REVIEW TYPE: Pre-preliminary Plan of Subdivision, Resubdivision of Existing Lot 20, and Part of Lot 16

PROJECT NAME: Congressional Forest Estates

CASE #: 720060570

STAFF RECOMMENDATION: Objection to submission of the preliminary plan

APPLICANT'S NEIGHBORHOOD MAP CONGRESSIONAL FOREST ESTATE (720060570)

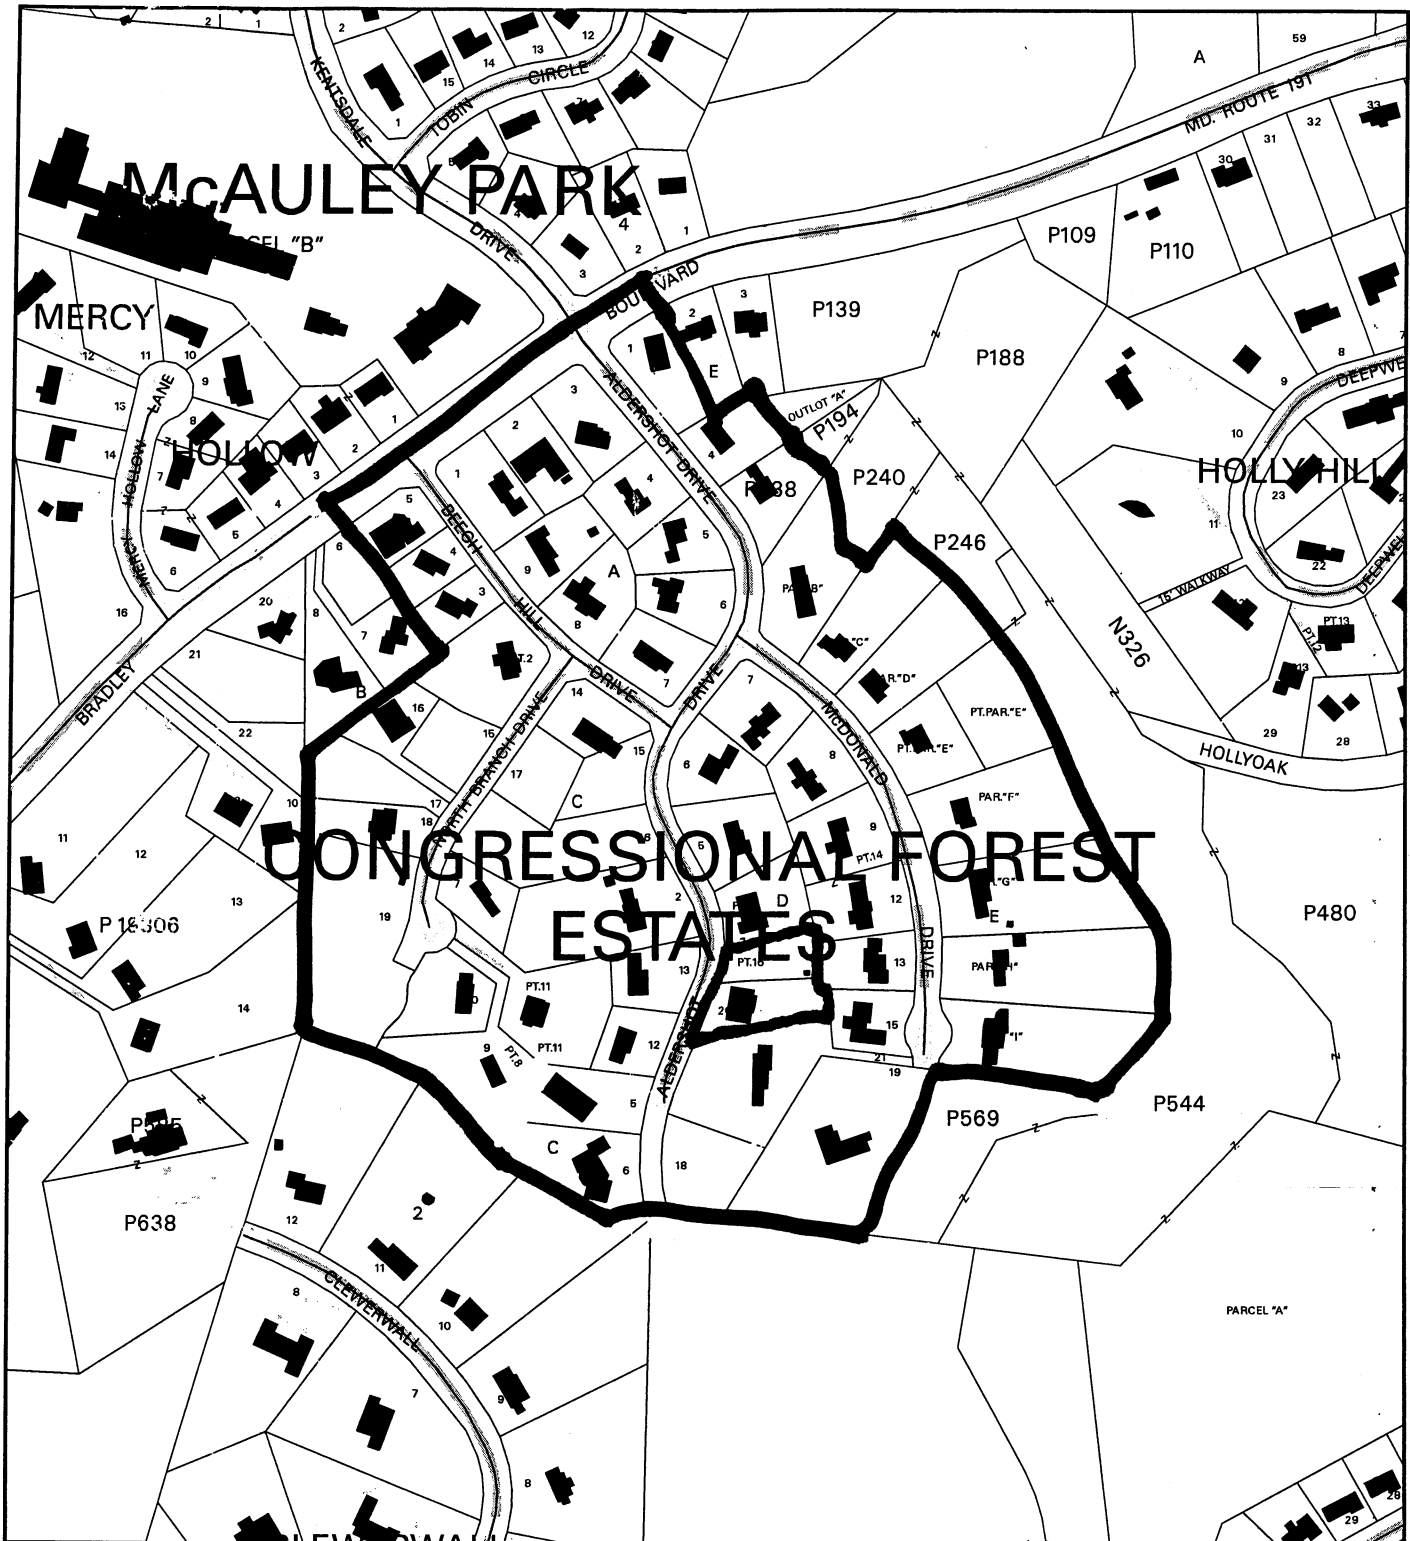
The Applicant has proposed a neighborhood of 42 lots for analysis purposes. The Applicant's neighborhood includes properties which extend south from Bradley Boulevard along Aldershot Drive, MacDonald Road, Beech Hill and North Branch Drive (Attachment C, Applicant's Neighborhood). Staff is of the opinion that the applicant's neighborhood delineation is inappropriate for the purpose of the proposed resubdivision for the following reasons:

- a.) Properties fronting on North Branch do not have frontage or access along the gateway streets, which lead into the neighborhood. The gateway streets are Beech Hill Drive and Aldershot Drive. The same is true for the lots on the east side of Macdonald Drive.
- b.) The lots and dwellings along North Branch Drive create a clustered community within itself because of the orientation of the lots, the number of irregularly shaped lots and the location of the dwellings on the lots.
- c.) The properties along North Branch are clustered in orientation and not comparable to the character of the lots fronting on Aldershot Drive, Macdonald Drive and Beech Hill Drive.

Staff's recommended neighborhood includes 32 lots and excludes properties fronting on North Branch Drive and on the east side of MacDonald Road (Attachment C-1). A tabular summary of lot data for both neighborhoods is also attached (Attachments D and D-1).
